## UNITED STATES PATENT AND TRADEMARK OFFICE

APPLICATION NO.	FILING DATE	FIRST NAMED INVENTOR	ATTORNEY DOCKET NO.	CONFIRMATION NO.
10/685,954	10/15/2003	Todd M. Wenger	H1799-00180	7947
8933 7	590 08/14/2006		EXAMINER	
DUANE MORRIS, LLP			FORD, JOHN K	
IP DEPARTM	ENT			
30 SOUTH 17TH STREET			ART UNIT	PAPER NUMBER
PHILADELPHIA, PA 19103-4196			3753	
			DATE MAILED: 08/14/2006

Application No.	Applicant(s)			
	10/685,954	WENGER, TODD M.			
Office Action Summary	Examiner	Art Unit			
	John K. Ford	3753			
The MAILING DATE of this communication appears on the cover sheet with the correspondence address Period for Reply					
A SHORTENED STATUTORY PERIOD FOR REPLY IS SET TO EXPIRE MONTH(S) OR THIRTY (30) DAYS, WHICHEVER IS LONGER, FROM THE MAILING DATE OF THIS COMMUNICATION.  - Extensions of time may be available under the provisions of 37 CFR 1.136(a). In no event, however, may a reply be timely filed after SIX (6) MONTHS from the mailing date of this communication.  - If NO period for reply is specified above, the maximum statutory period will apply and will expire SIX (6) MONTHS from the mailing date of this communication.  - Failure to reply within the set or extended period for repl

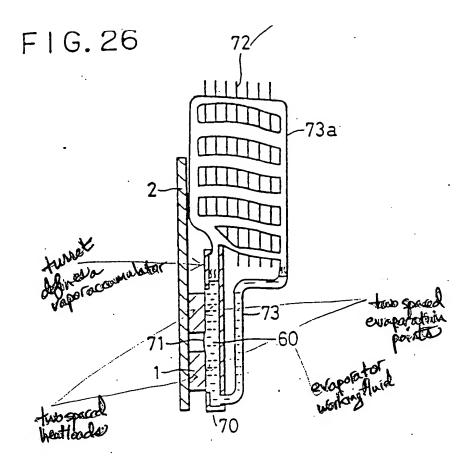
See Figures 25 and 26, in particular. In both figures, a plurality of loads 1 is shown. The evaporator working fluid 60 is located adjacent to the plurality of loads 1, inside of a closed envelope. In both figures, a finned condenser is shown above the evaporator. A vapor line and a separate liquid return line are shown in both figures. The "at least two spaced evaporation points" are shown adjacent to a respective one of the plurality of loads 1. Liquid phase is commonly supplied to these "at least two spaced evaporation points."

Regarding claims 2 and 3, the reservoir is shown at reference numeral 71 in Figure 26 and at a corresponding location (having no numeral) in Figure 25.

Regarding claims 5 and 14, reference numeral 71 in Figure 26 is a recessed well that satisfies all if the limitations claimed including the "stepped edges" (adjacent to the two heat loads 1).

Regarding claims 15 and 16, see the diagram below, where the examiner has annotated Figure 26 of Hisano et al to show the claimed parts.
